Updated ACT Text Proposal

Contribution to 802.3dm Task Force

July 21, 2025

Added State Diagram

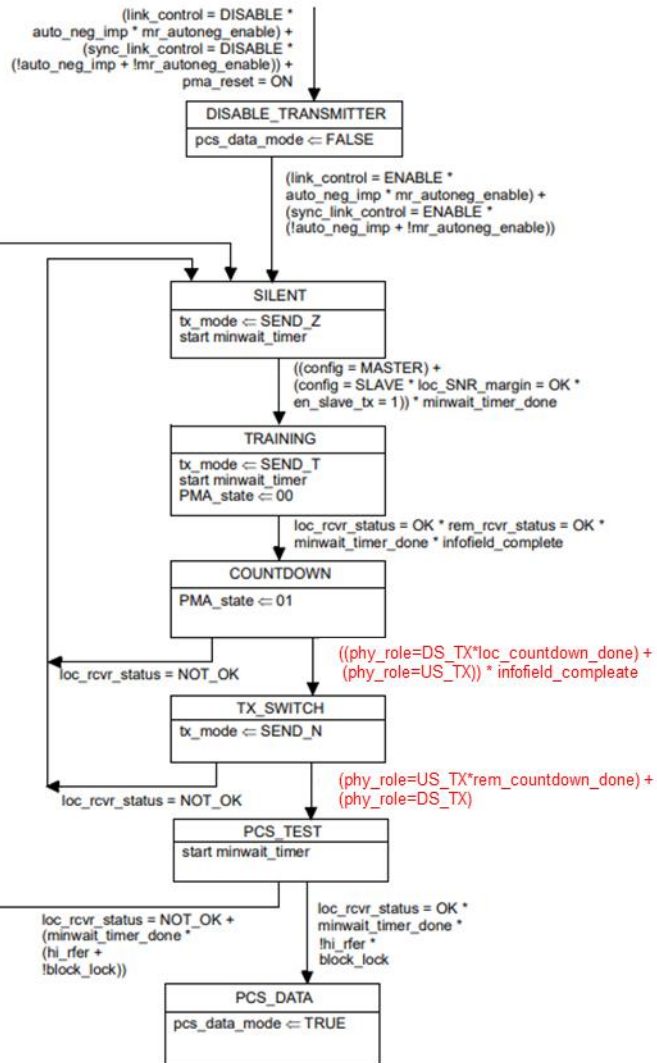
- Previous presentations referenced the 802.3ch state diagrams, but the updated proposal shows the 802.3dm PHY control state diagram, including minor updates to the state transition criteria, to reflect the asymmetric modulation

- There are minor changes relative to the 802.3ch to reflect the asymmetric modulation

- The updates are reflected in Clause 200.7.6

Figure 200-5—Training frame

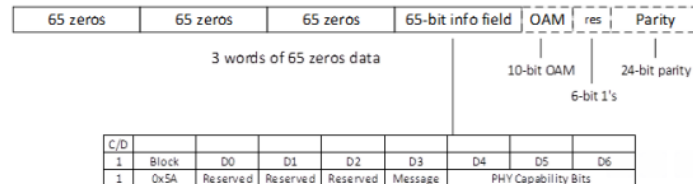
- The 100M training frame format has been described in more detail

- Provided more detailed description of the 100M training frame

The four training frame 64B/65B blocks then have the sixteen OAM/Reserved bits and the 24 FEC parity bits, as shown in Figure 200-5..

- The updates are reflected in Clause 200.5.5
